# Minutes of 89<sup>th</sup> PCC Meeting

### **MINUTES OF 89<sup>TH</sup> PROTECTION SUB-COMMITTEE MEETING HELD AT ERPC, KOLKATA ON 13.03.2020 (FRIDAY) AT 11:00 HOURS**

## 2. DR of 400 kV Binaguri - New Purnea -1 at Binaguri at 04:11 on 16-02-2020

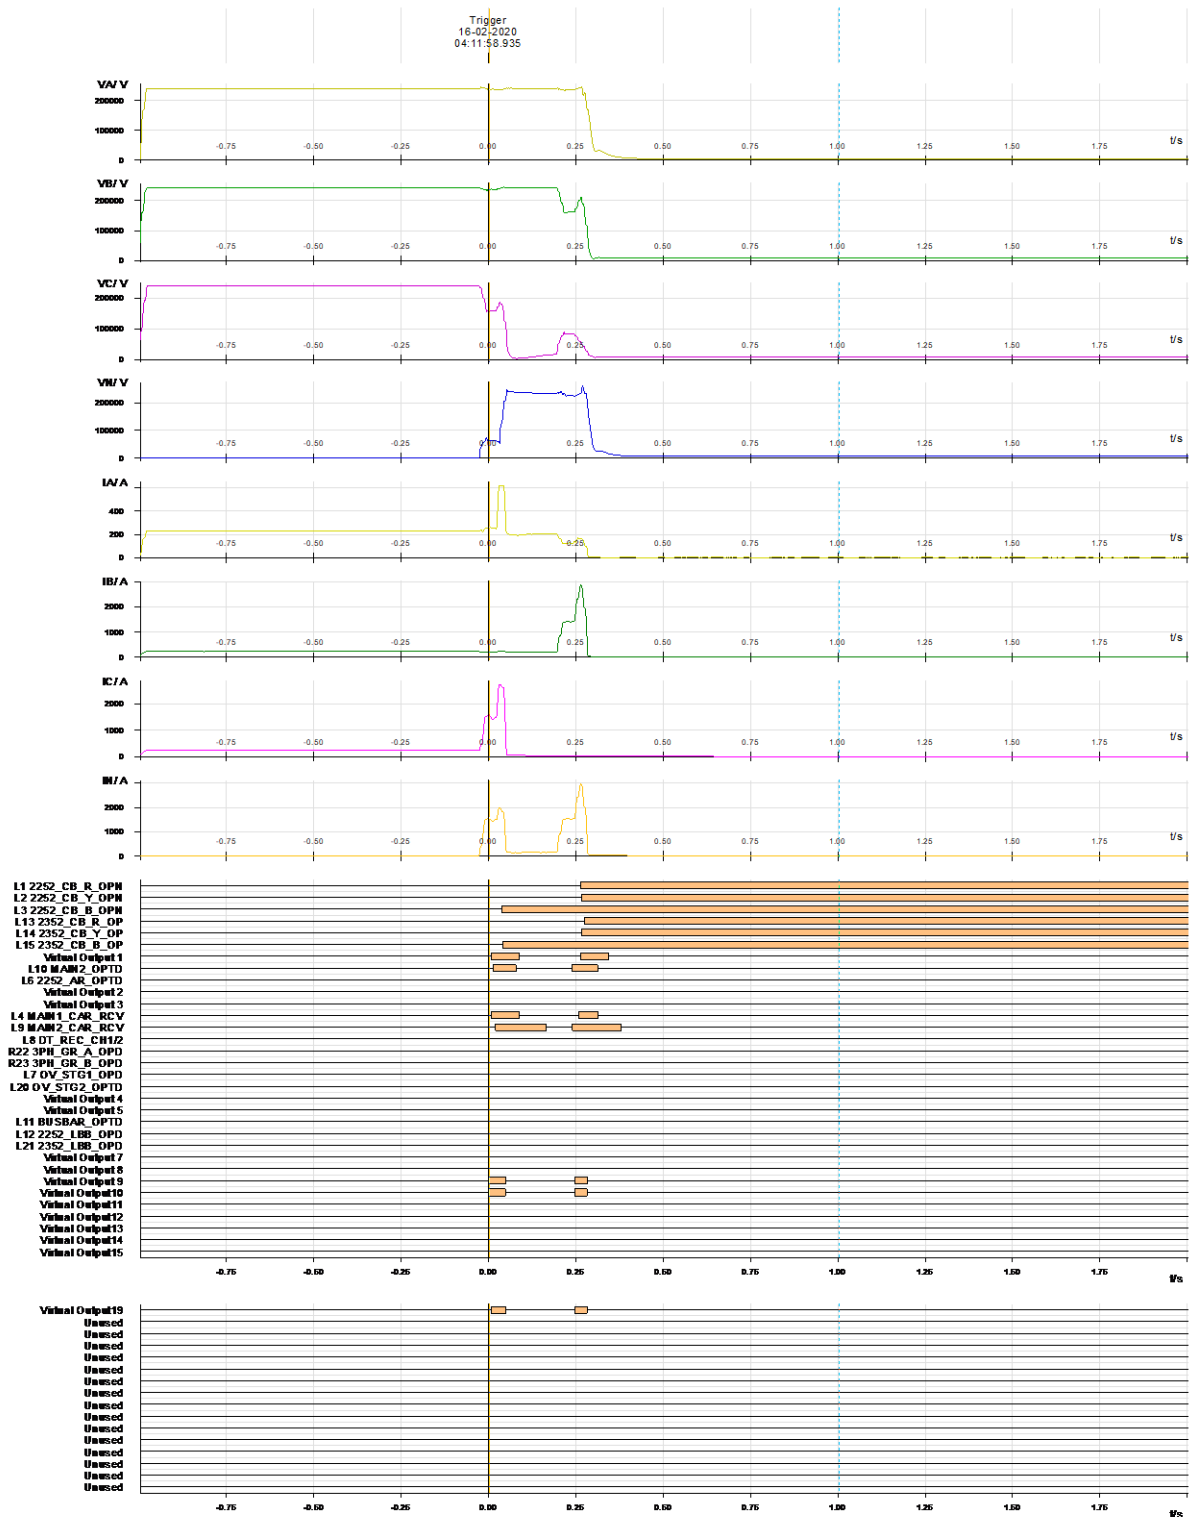
Issue: DR not properly configured;

### 3. DR of 400 kV Binaguri - New Purnea -1 at New Purnea at 04:11 on 16-02-2020

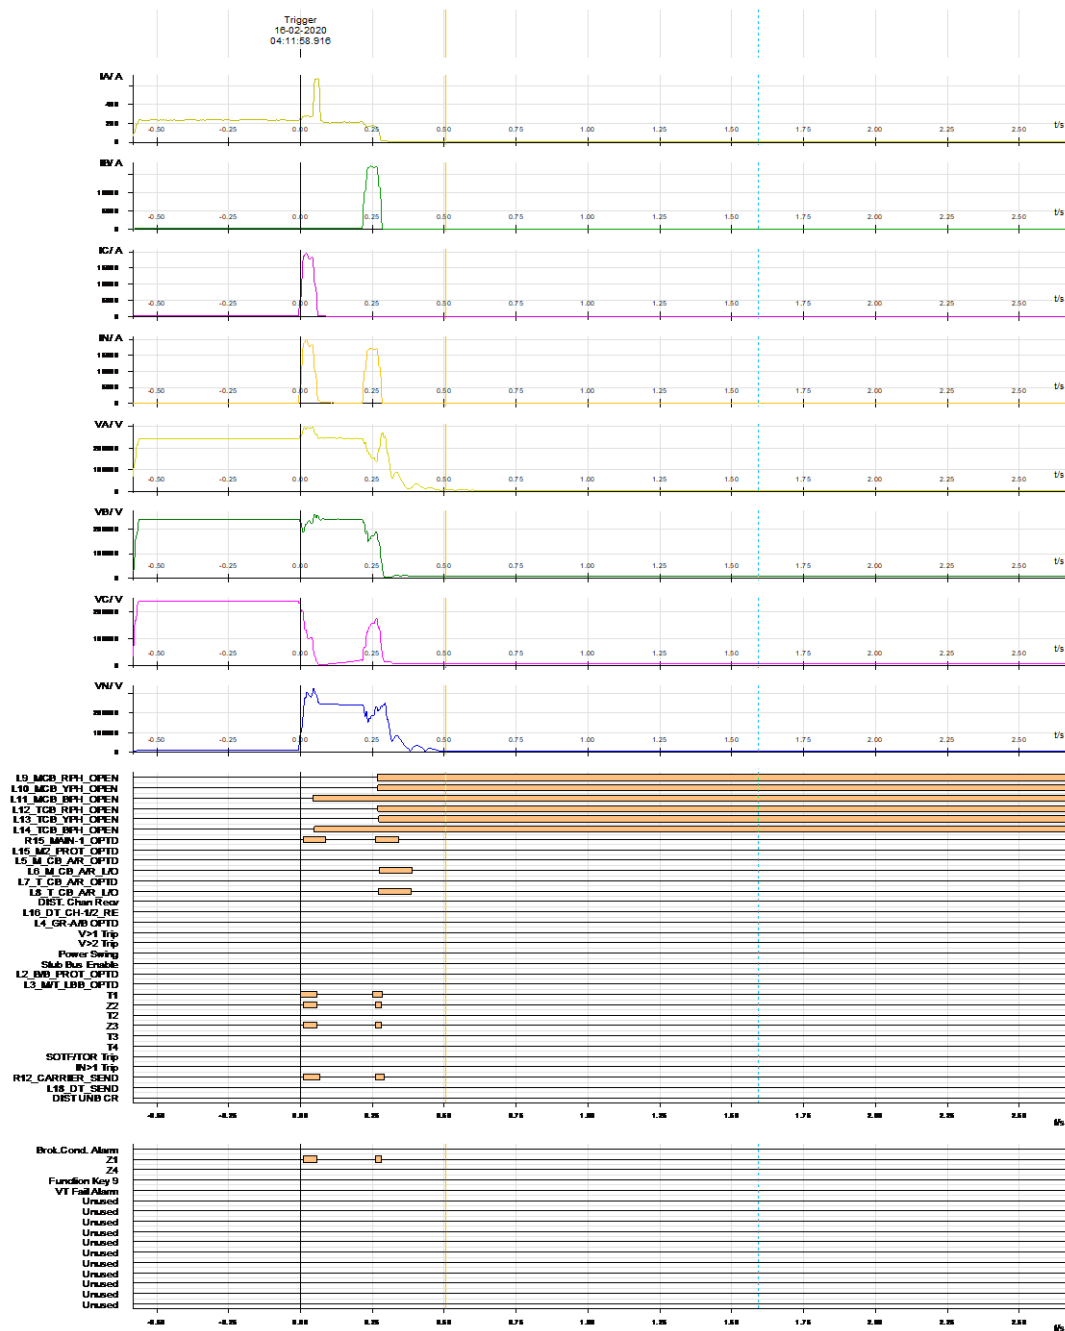
Issue: Main II protection not operated as per main I DR

## 5. DR of 400 kV Binaguri - Alipurduar - 3 at Binaguri at 09:16 on 19-02-2020

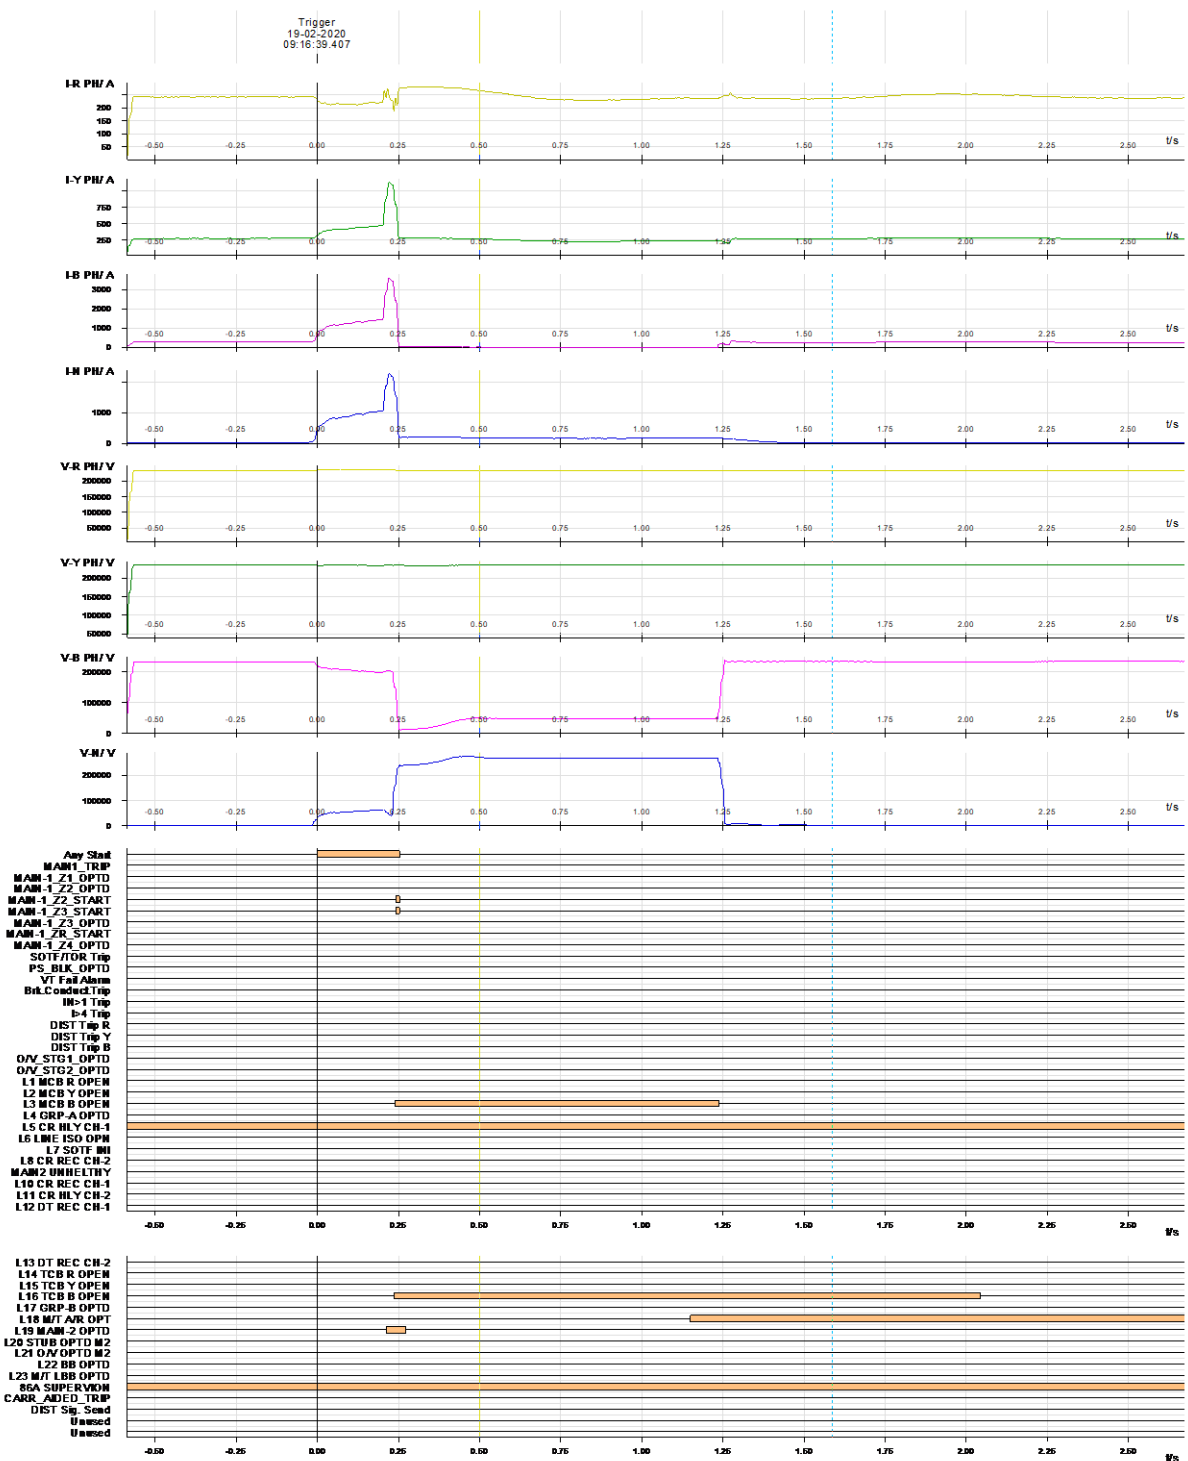
Remarks: Whether line tripped by main I or main II protection? If tripped by main II, main II DR required. Z-I trip did not pick up in main I DR, in case of successful A/R operation

## 8. DR of 400 kV Binaguri - Alipurduar - 3 at Binaguri at 17:04 on 25-02-2020

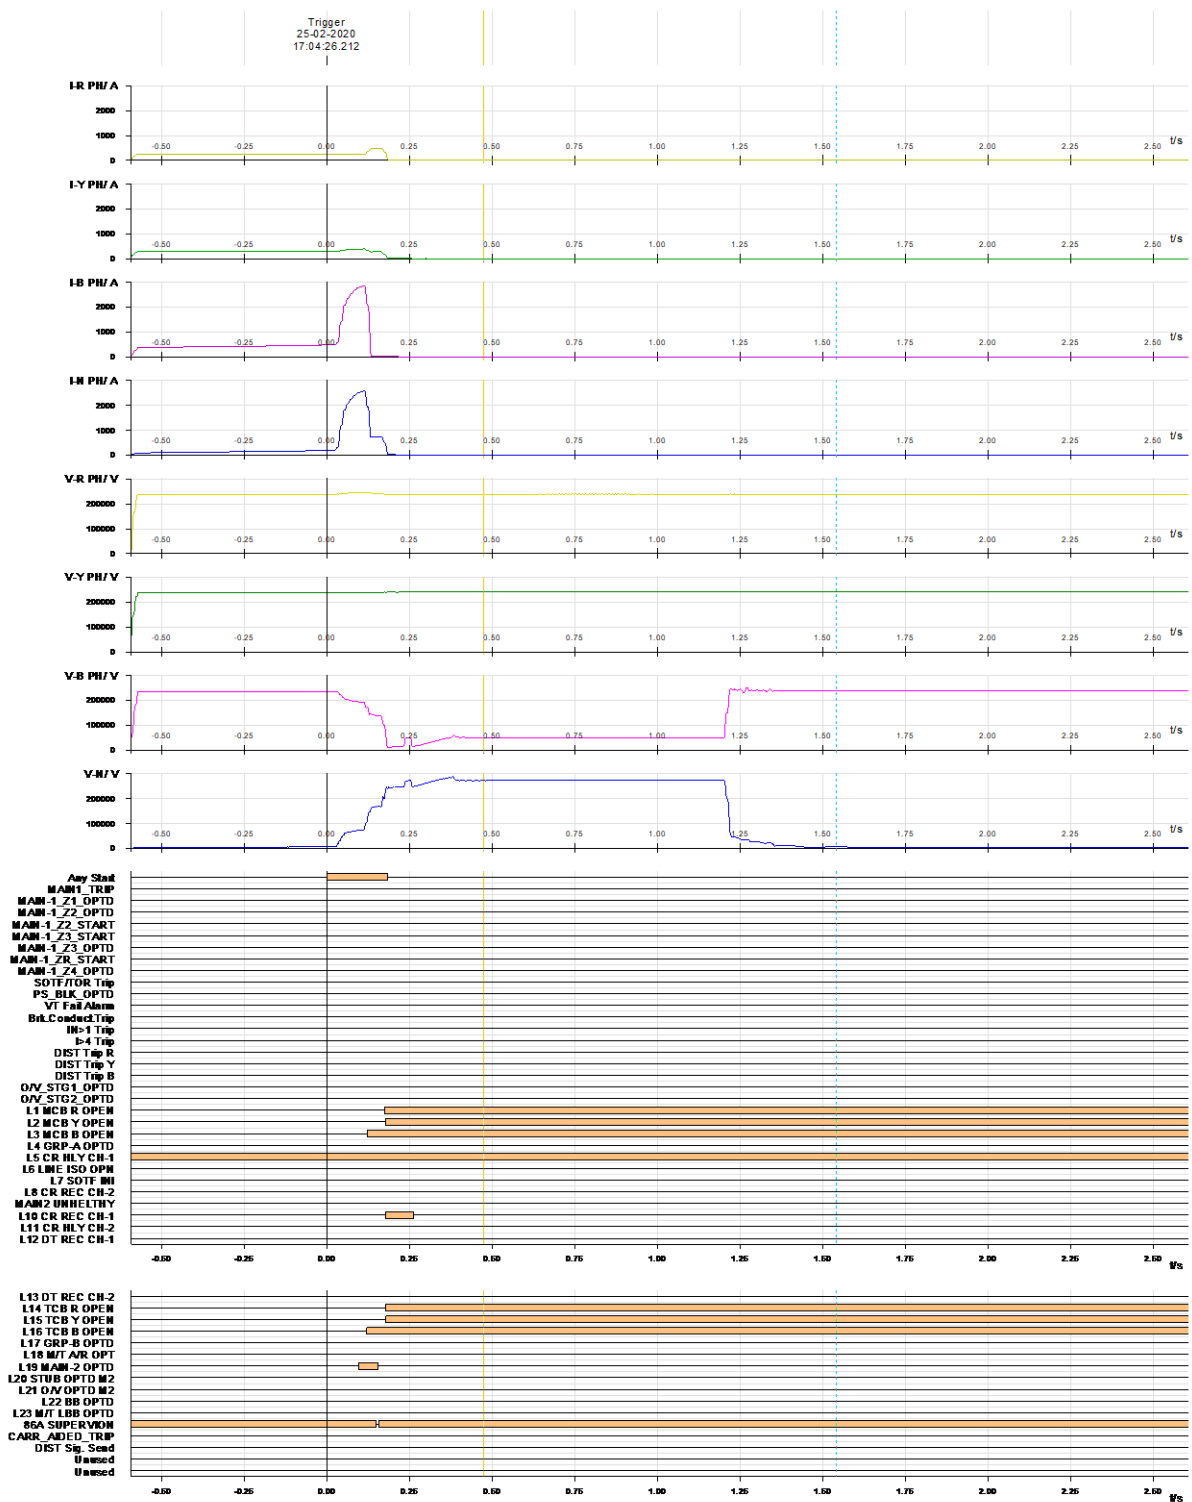
Issue: In main I DR, no reason of tripping recorded; Main II DR not received

## 9. DR of 400 kV Gaya - Koderma - 2 at Gaya at 09:19 on 25-02-2020

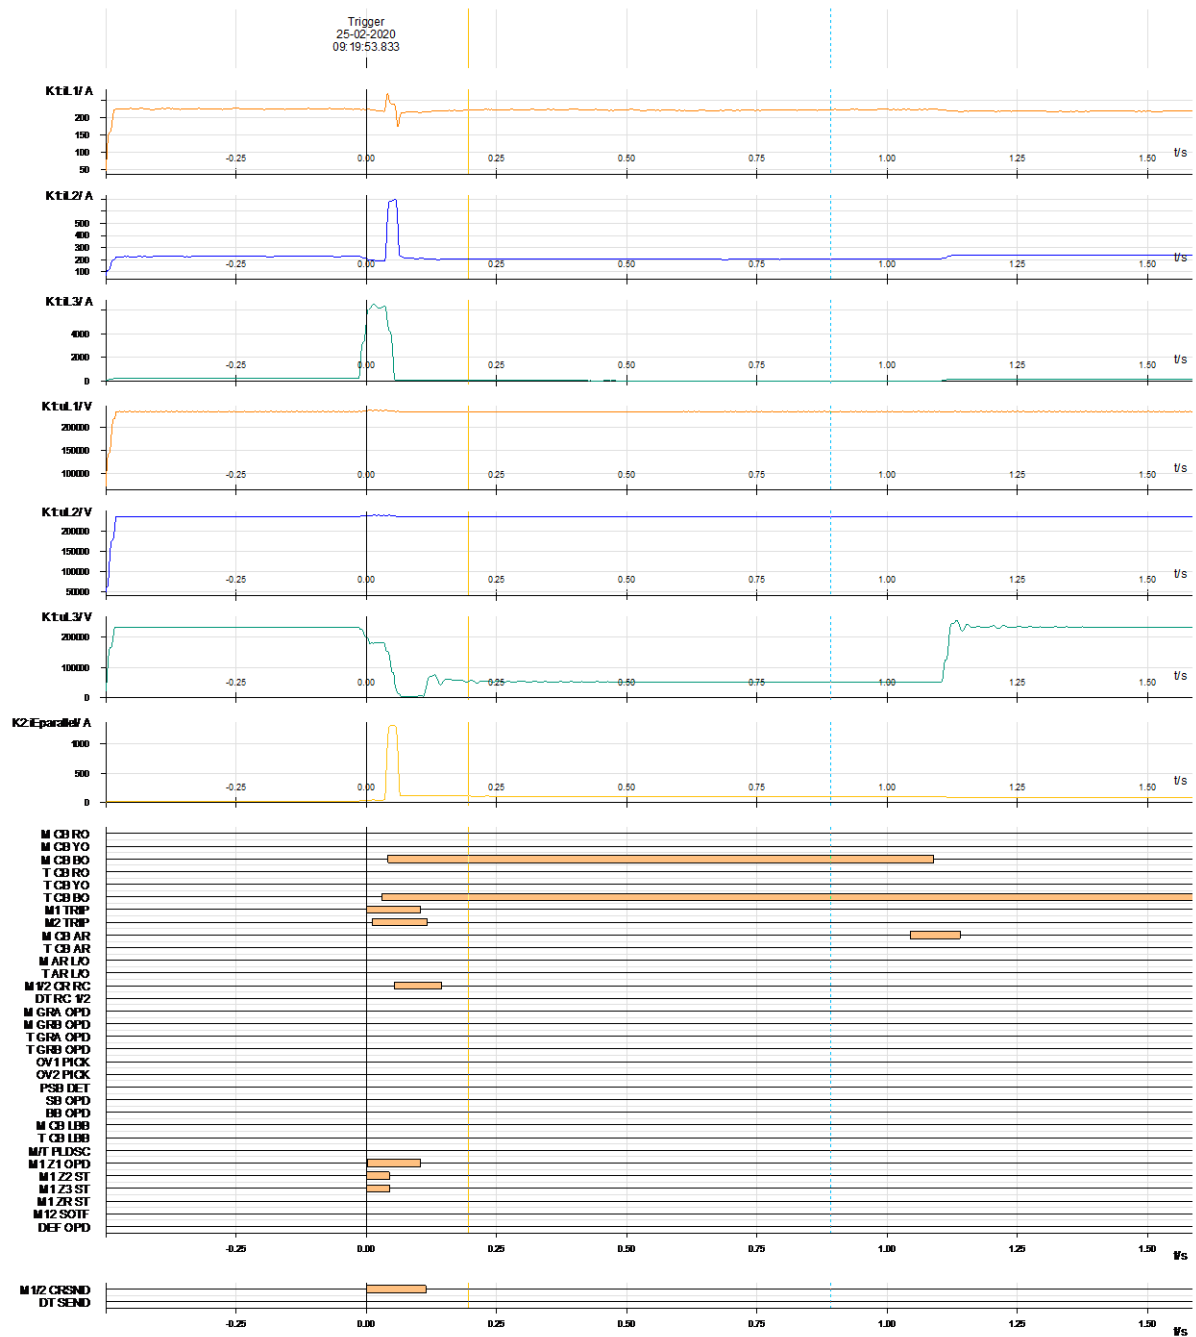
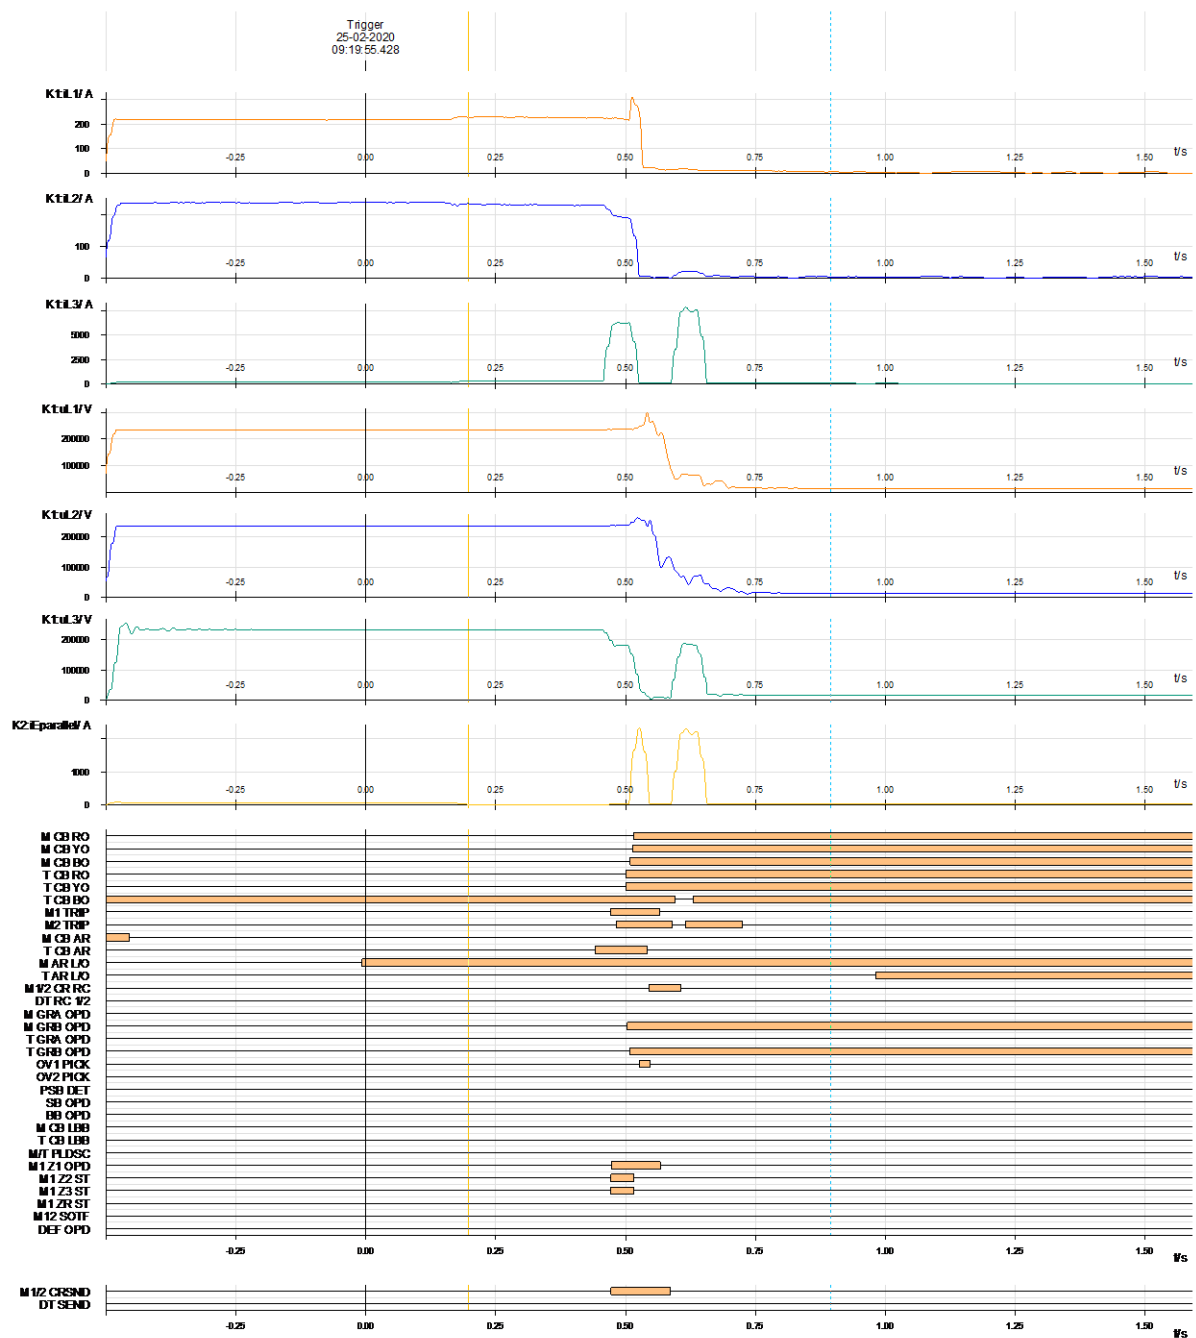
Issue: Post fault DR time window around 1.5 seconds, tie breaker A/R operation not properly captured; Even after tripping of main breakers and remaining poles of tie breakers, A/R operation of B pole tie breaker took place

# 10. DR of 400 kV MPL - Maithon - 2 at Maithon at 09:58 on 26-02-2020

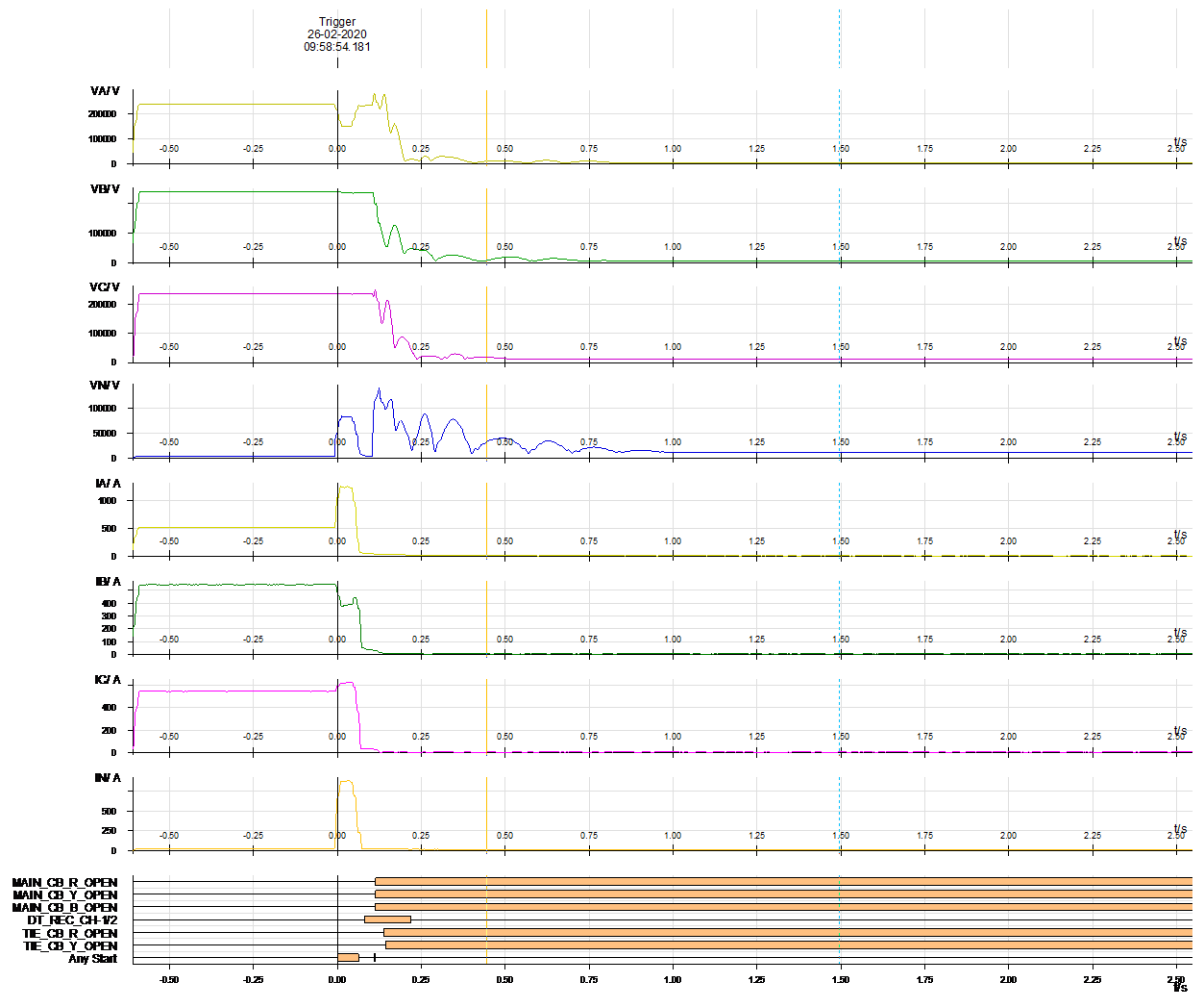
Issue: DR not properly configured
